## ADDENDUM NO. 1

PROJECT: Saline Area Schools – 2022 Bond Program – MS Rec Complex  
 DESCRIPTION: Addendum No.1  
 BID PACKAGE RELEASE NUMBER: BP #3

1. ADDENDUM No. 1, November 20<sup>th</sup>, 2024 as issued by Kingscott (Attached)
2. Bid Package T4 Draft Drawings, October 22<sup>nd</sup>, 2024 - Saline Middle School Rex Complex as issued by Barton Malow (For Reference Only)

SHEET NO.  
**C6.5**

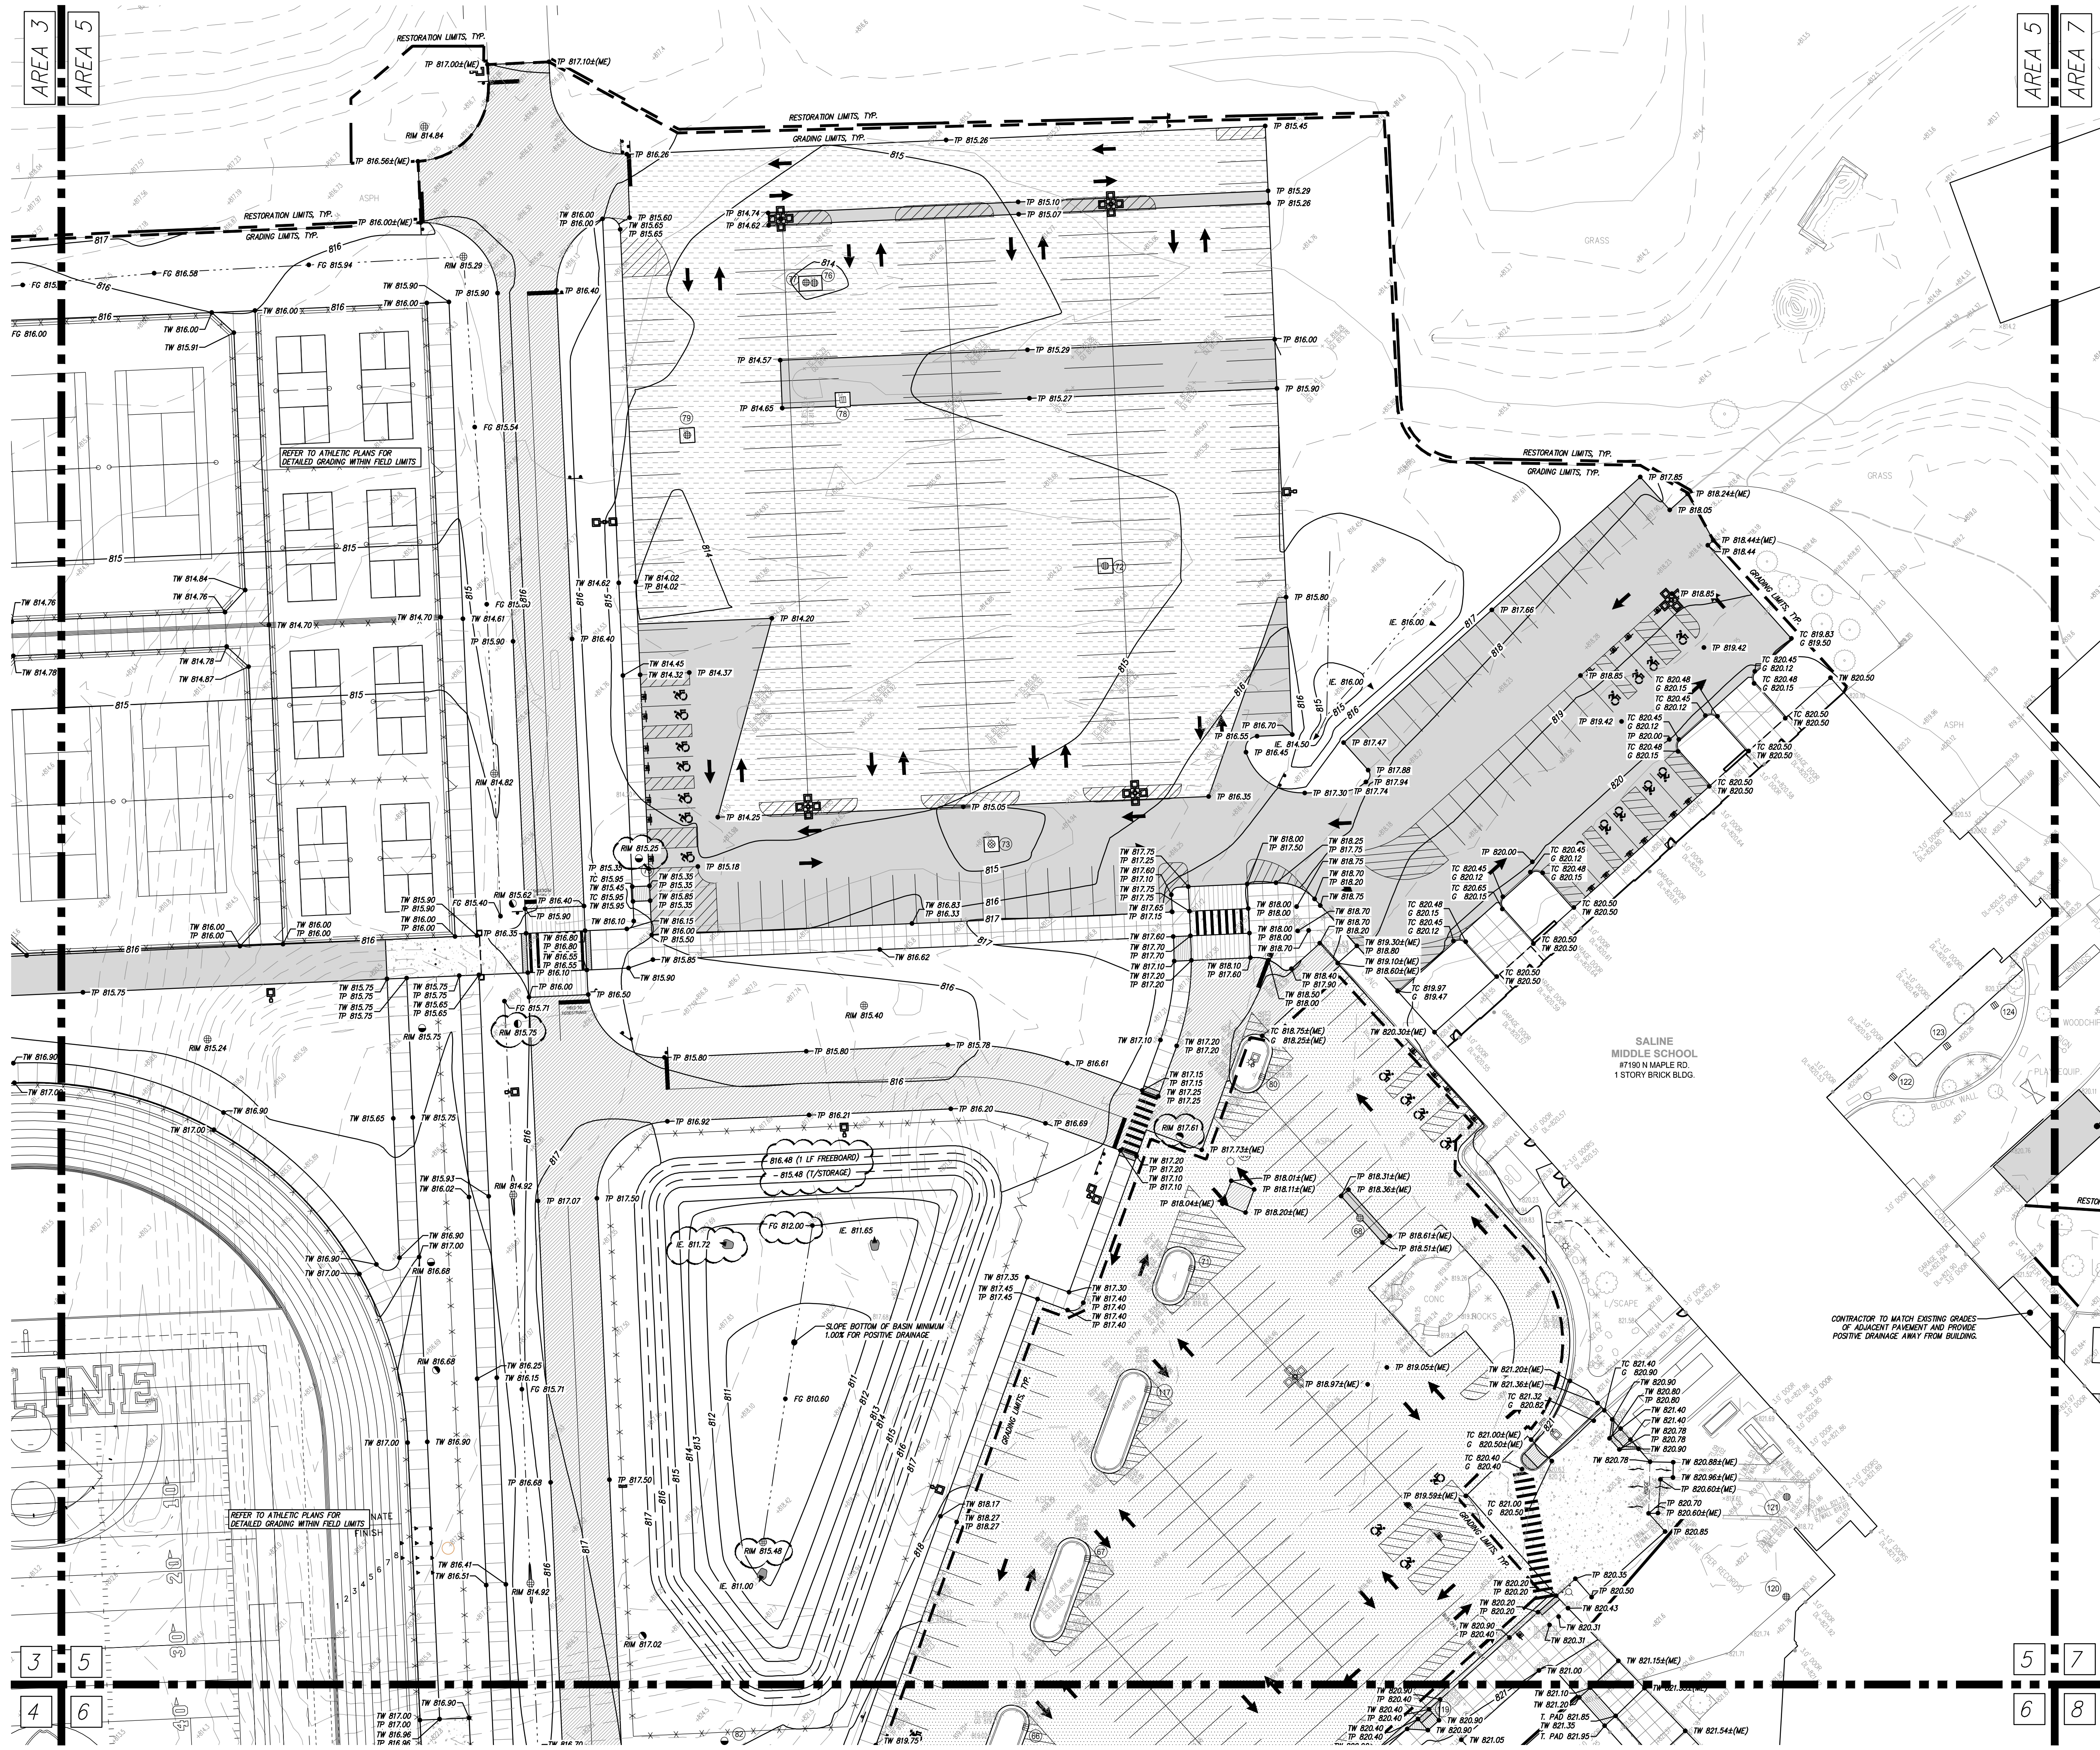
- Item No. 76: Added "Top of Storage" and "Freeboard" elevations on sheet C6.5.
- Item No. 77: Updated spot grades per grading changes on sheet C6.5.
- Item No. 78: Updated inverts and rim elevations per utility layout changes on sheet C6.5.

- Item No. 79: Added missing rim elevations to storm structures on sheet C6.5.
- Item No. 80: Updated location of "Freeboard" label on sheet C6.8.
- Item No. 81: Updated "Wayfinding Sign Detail" on sheet LA2.0

SHEET NO.  
**L2.04**

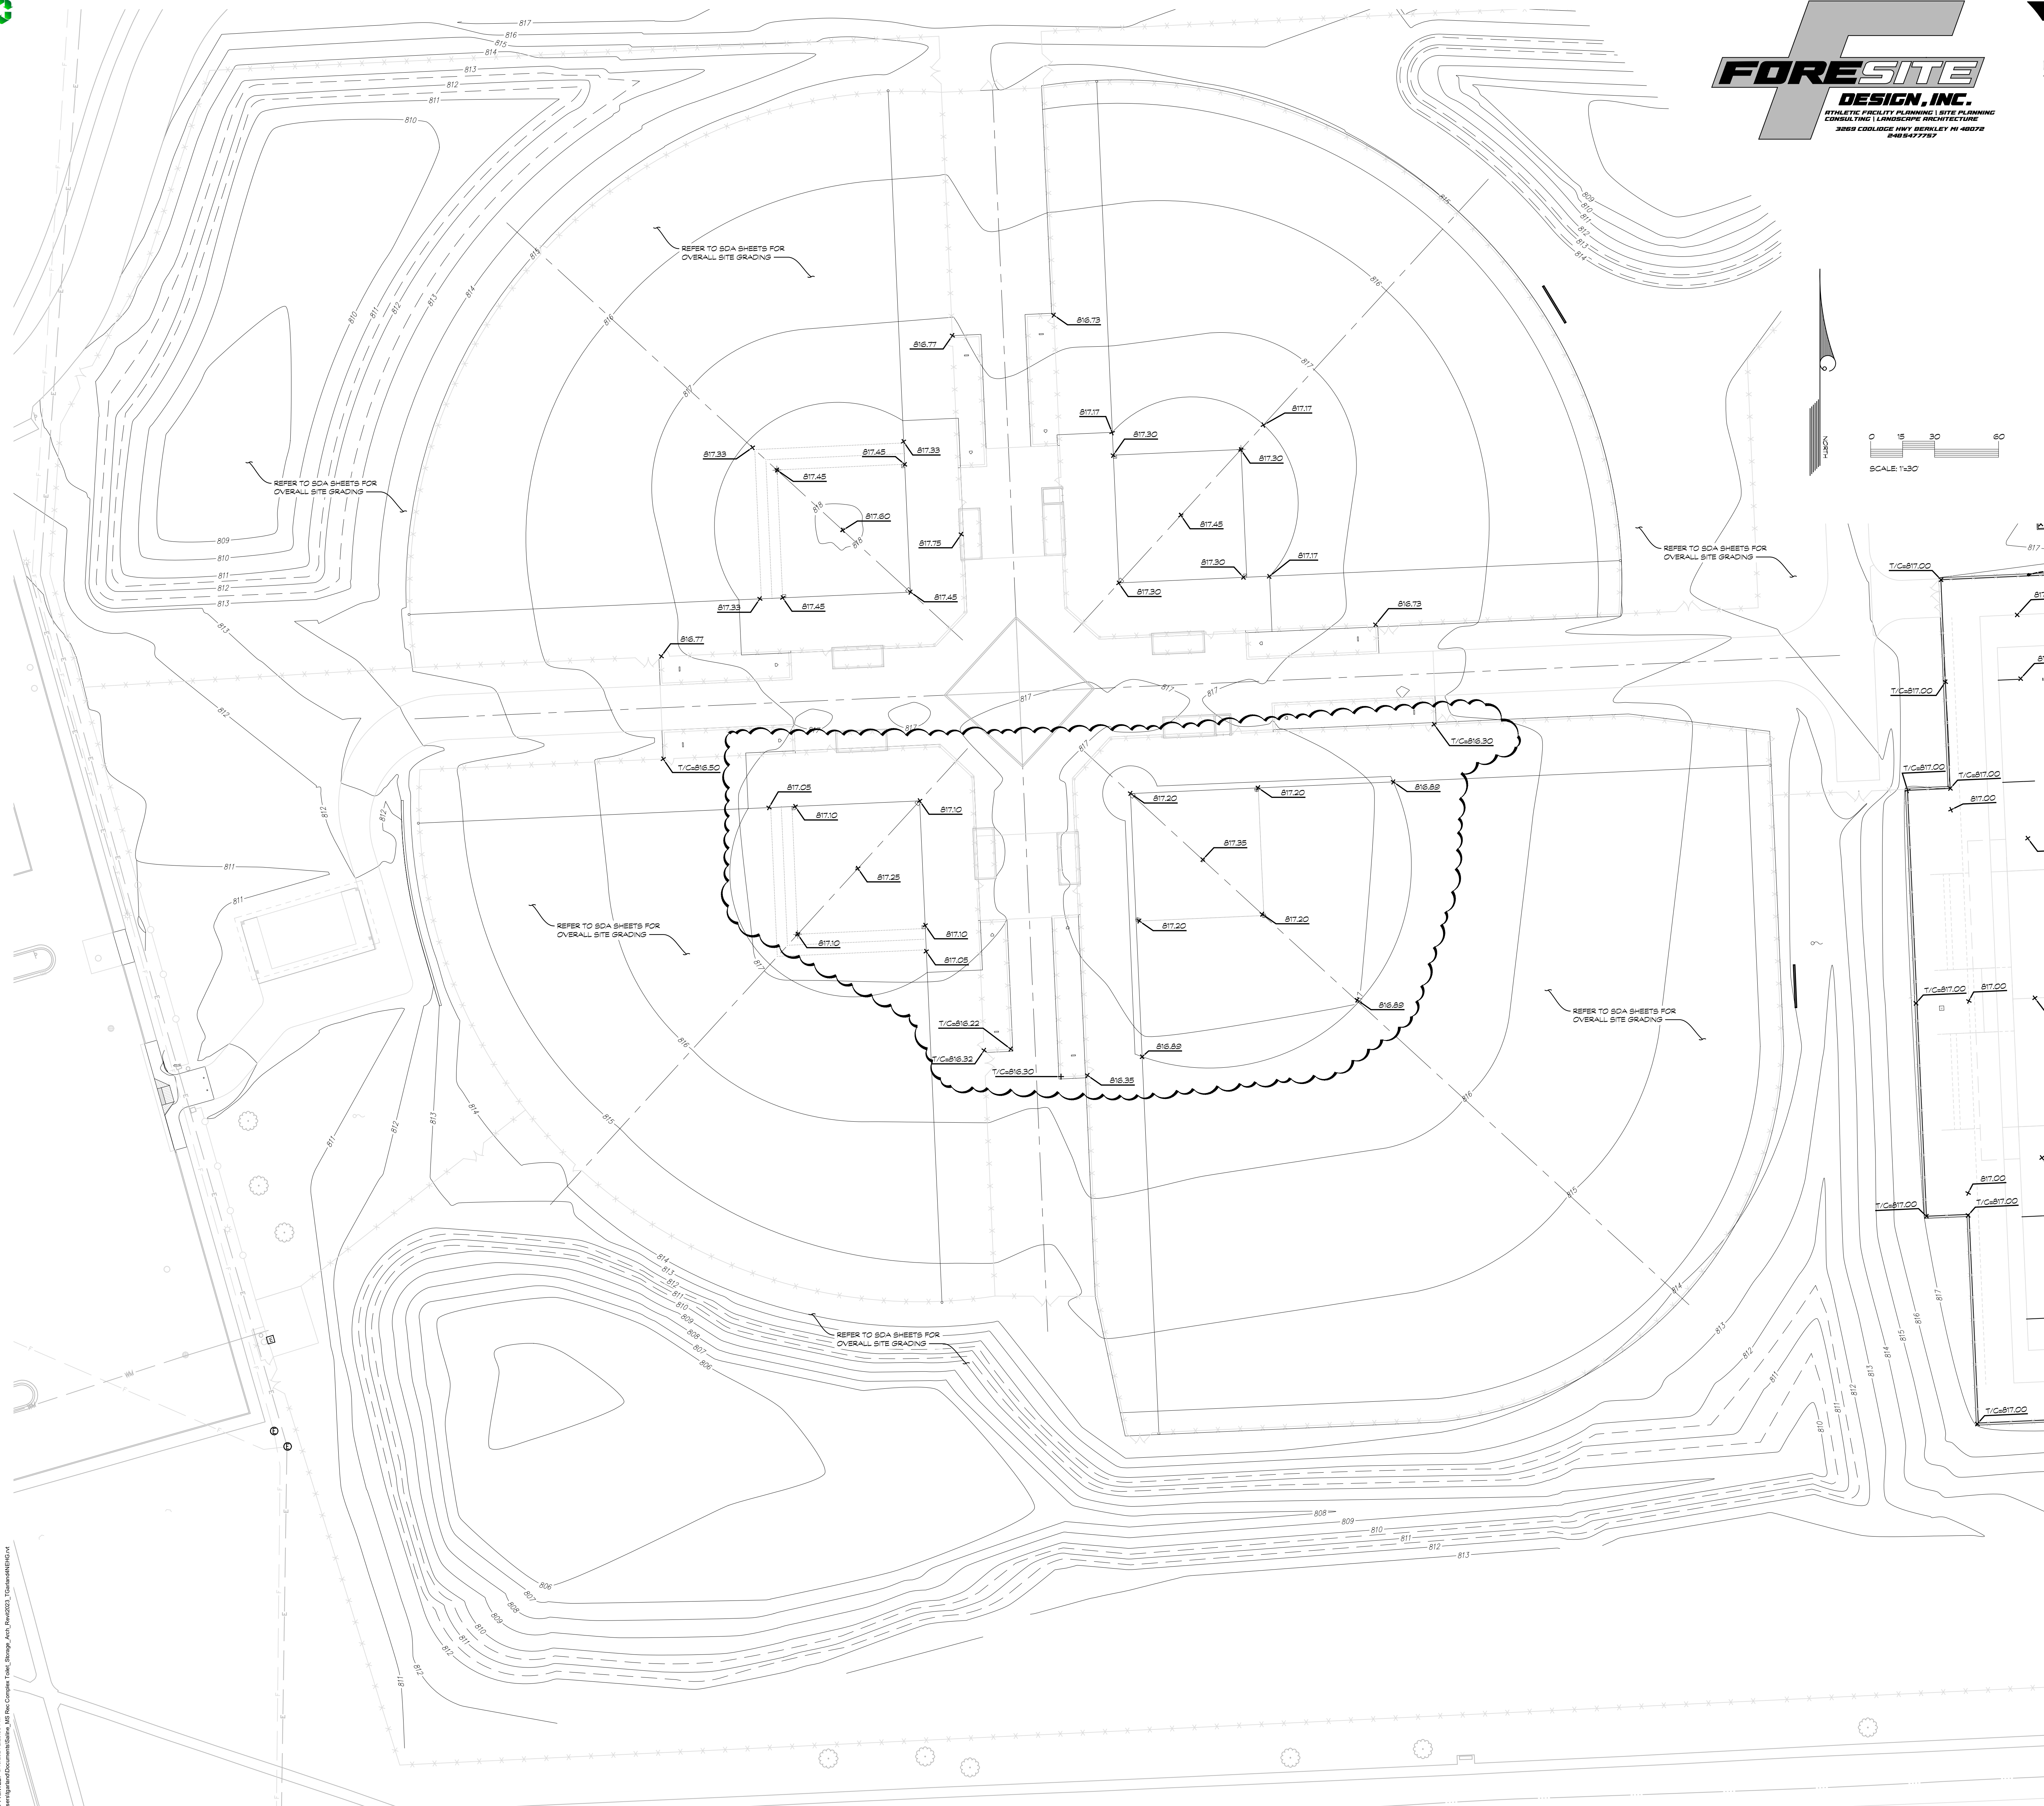
- Item No. 82: Added note for sod to sheet L2.01.
- Item No. 83: Revised spot grade elevations at (2) ballfields on sheet L2.04.
- Item No. 84: Revised inverts and outlet locations to coordinate with civil on sheet L2.05.

SHEET NO.  
**L3.04**

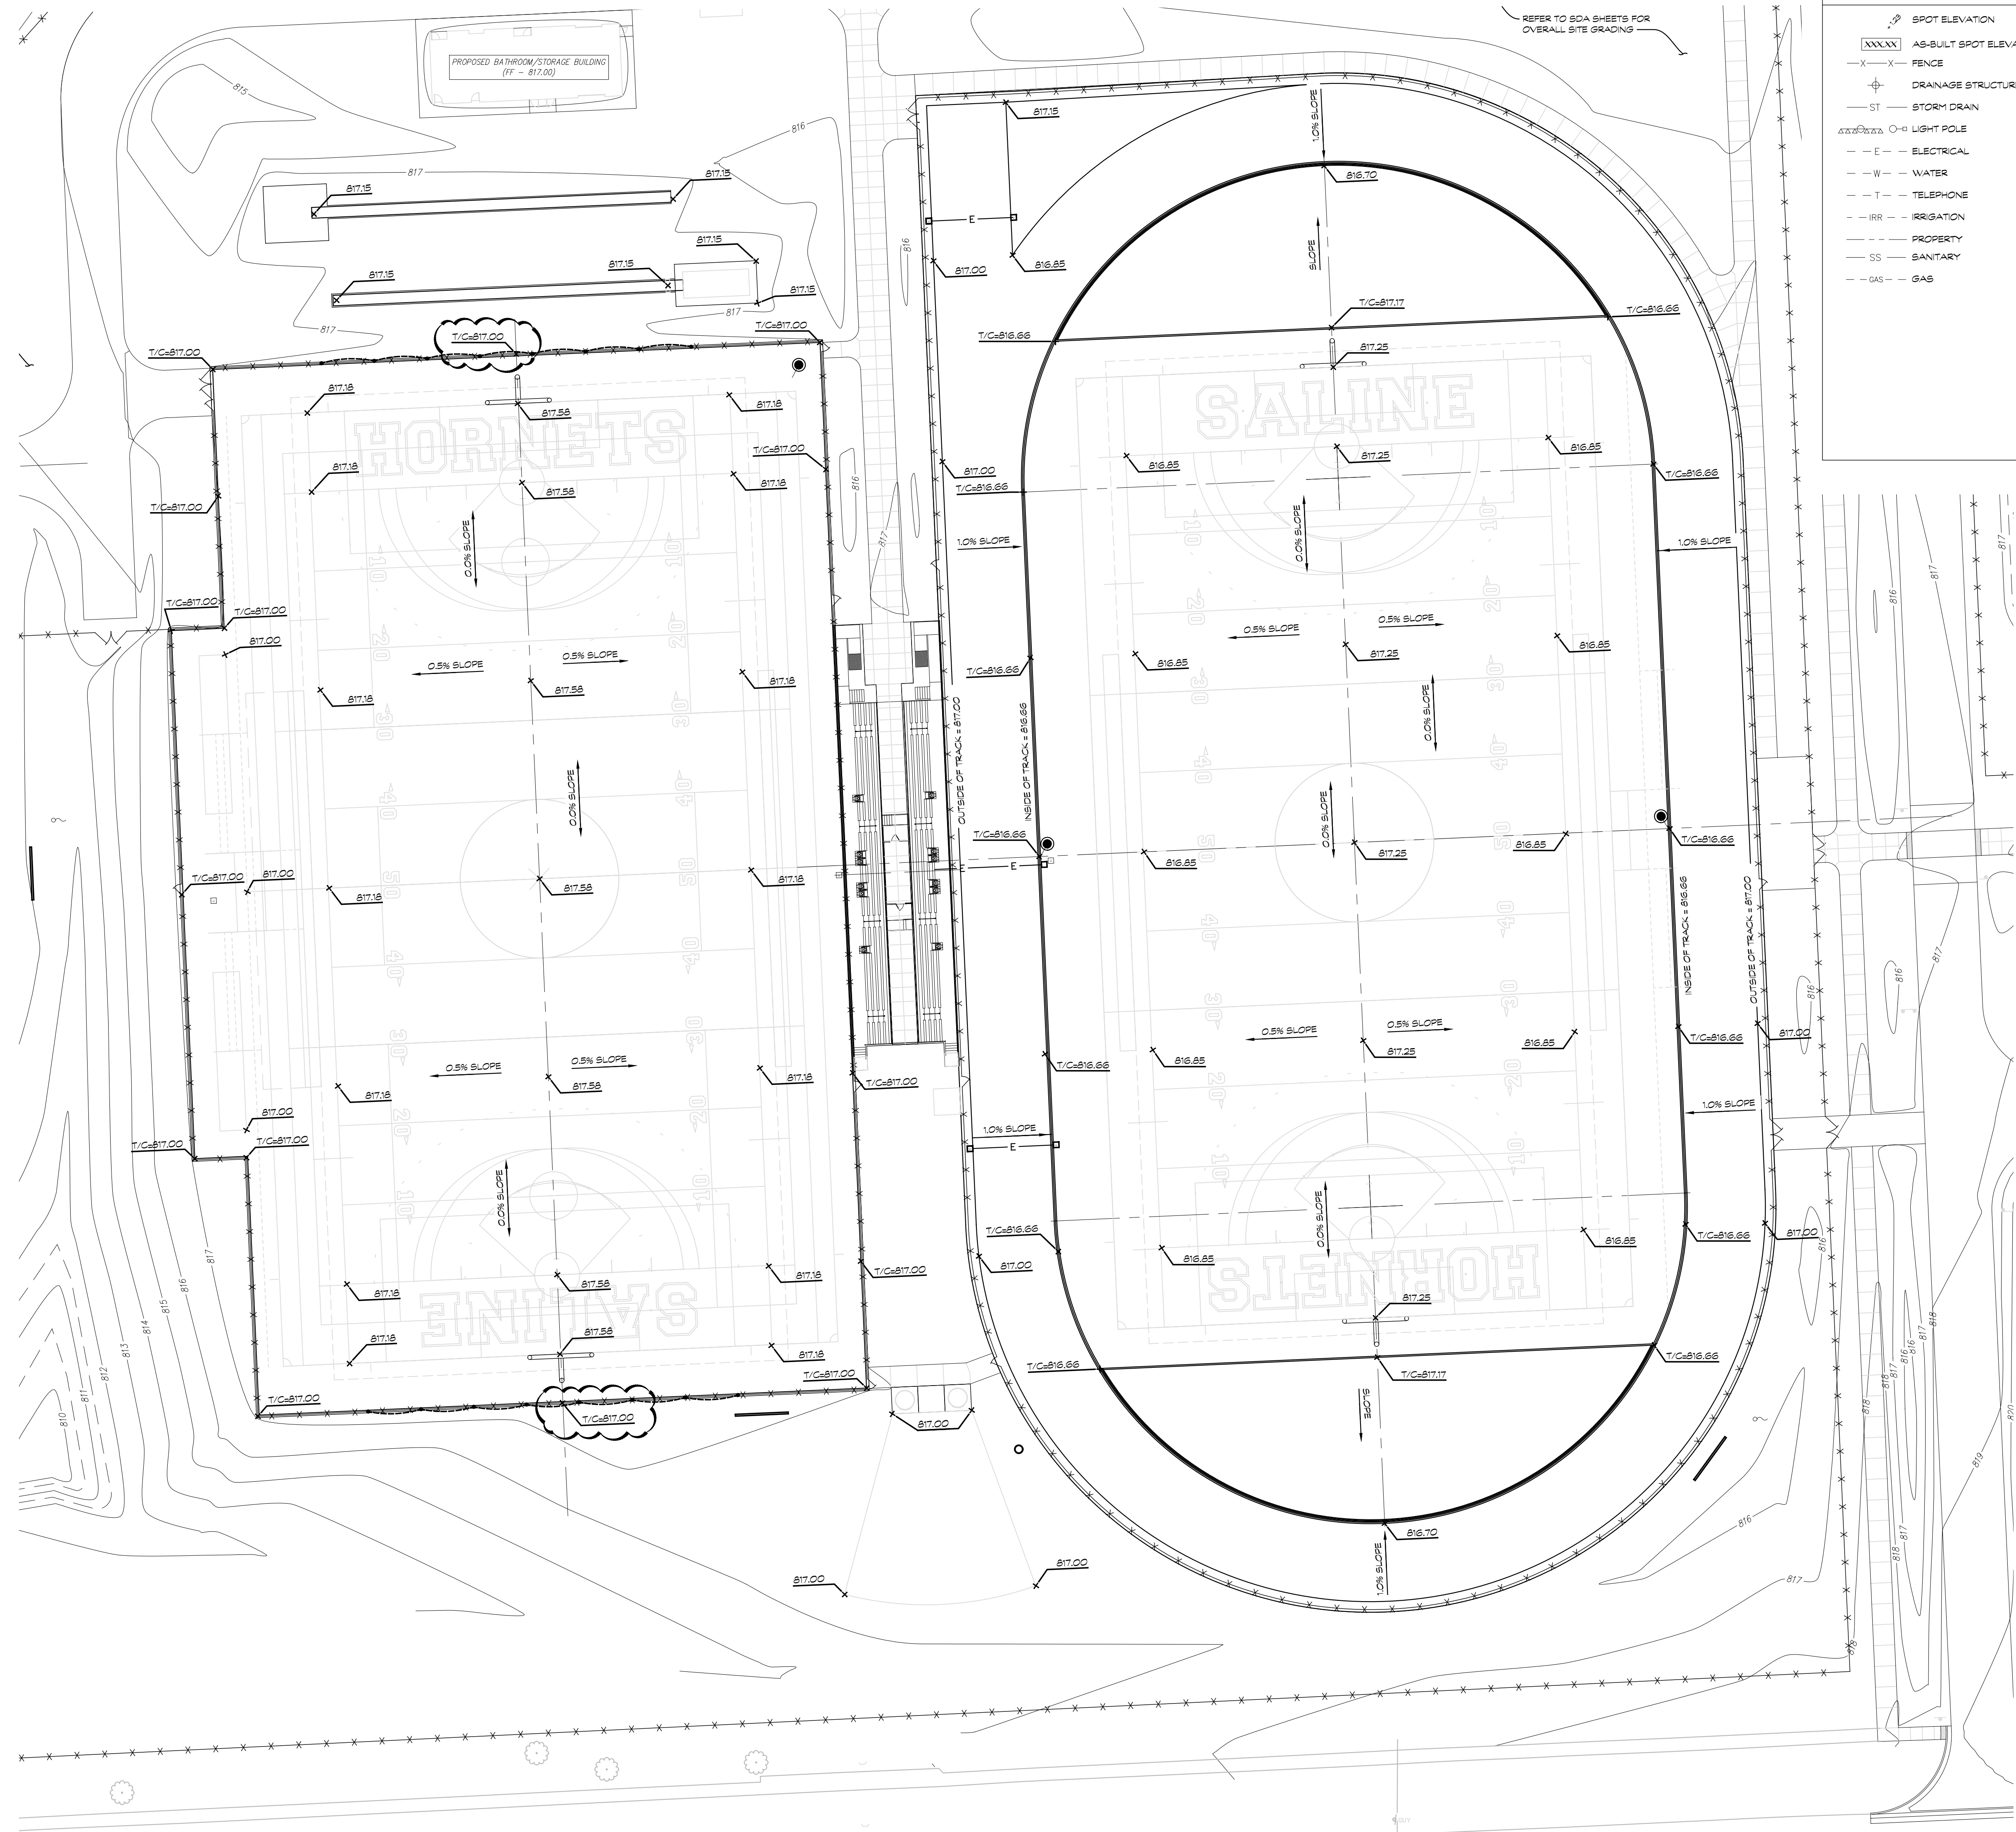
- Item No. 85: Added spot grade elevations on sheet L3.04.
- Item No. 86: Revised inverts and outlet locations to coordinate with civil on sheet L3.05.
- Item No. 87: Revised specification section 13 3500 Grandstands to align with design intent.
